LETTER AND ATTACHED U S NAVY RESPONSE TO U S EPA REGION III COMMENTS ON  
THE TIER II SAMPLING AND ANALYSIS PLAN FOR SITE 4 REMEDIAL INVESTIGATION  
WILLIAMSBURG FISC VA  
6/27/2012  
CH2M HILL

**Response to Comments**  
**Tier II Sampling and Analysis Plan**  
**Site 4 – Remedial Investigation**  
**Naval Weapons Station Yorktown Cheatham Annex**  
**Williamsburg, VA**  
**June 26, 2012**

Site 4/AOC 3 Results  
Cheatham Annex  
Williamsburg, Virginia

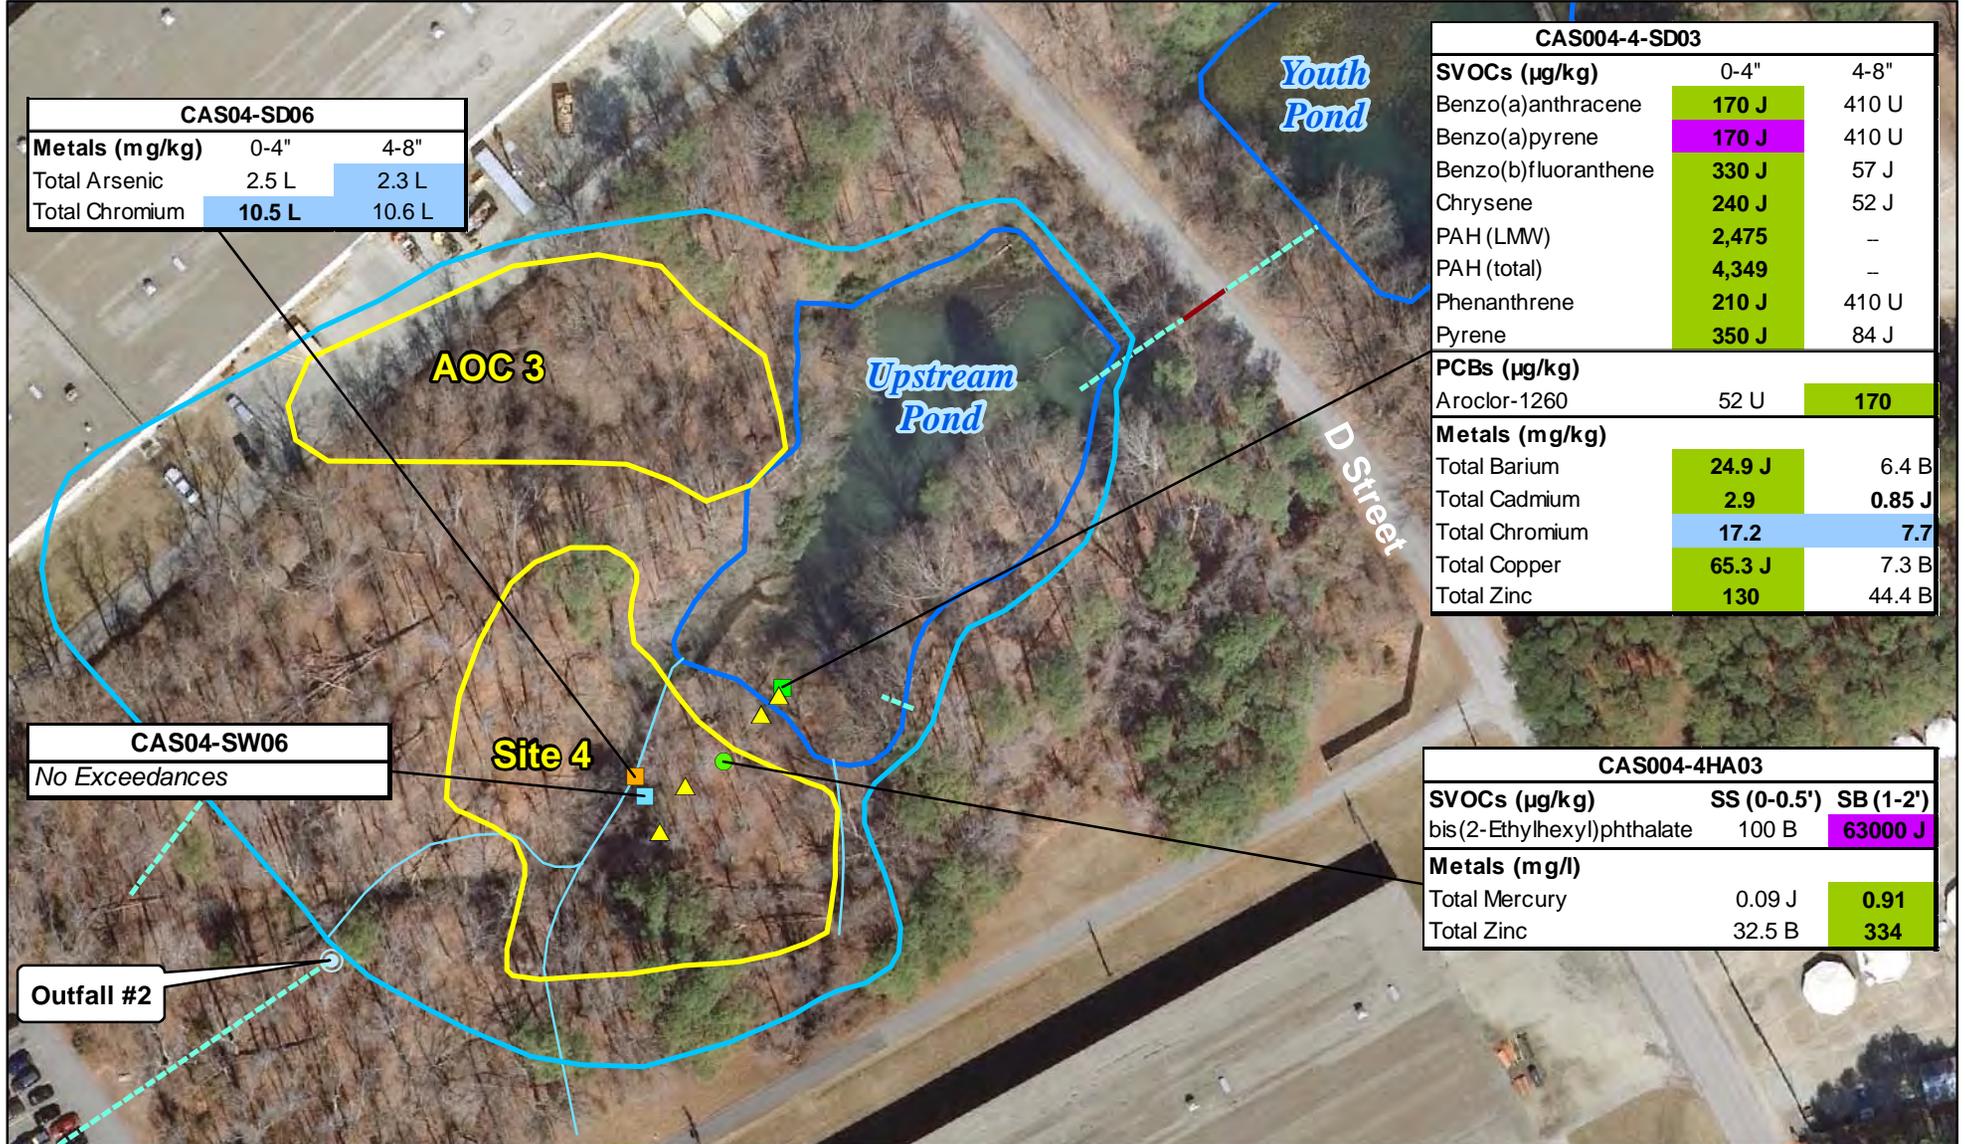
*EPA RPM Comment 3: Pages 22 and 23. Was the area with the railroad ties and drum sampled.*

Response: Surface debris, including railroad ties (among other debris), was encountered throughout Burial Investigation Area 2 as indicated in the SAP. During a recent site visit, the locations of a few of the areas where railroad ties were observed at the ground surface were recorded with a GPS. These locations are shown on the attached figure and show that several site samples were collected in the vicinity of or downgradient of the railroad ties (specifically, CAS04-SD06, CAS04-SW06, CAS004-4-SD03, and CAS004-4HA03). No changes to the SAP were made.
